## Errata to TFP101(A), TFP201(A), TFP401(A), TFP403, Datasheet Literature Numbers SLDS116A, SLDS119A, SLDS120A, SLDS125A

### 1. Power pad dimension.

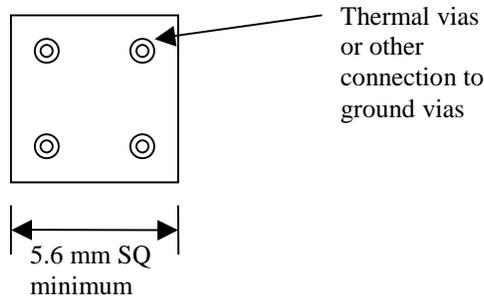
The size of the exposed metal on the PowerPad package figure is shown as larger than on production devices. When providing a thermal land, it may be smaller than assumed from the package drawing. If routing traces under the power pad, some method of protection from shorts between the traces or vias and the PowerPad should be used.

In the package drawing page, change the package figure as described:

a) Re-size the thermal pad dashed box from its present size to 5.05mm, centered in the package.

Add dimensions to re-sized pad showing:  $\frac{5.05}{3.95}$  SQ

c) Change note D to read:

The package thermal performance may be enhanced by bonding the thermal pad to an external thermal plane. This pad is centered on the package and is electrically and thermally connected to the backside of the die.
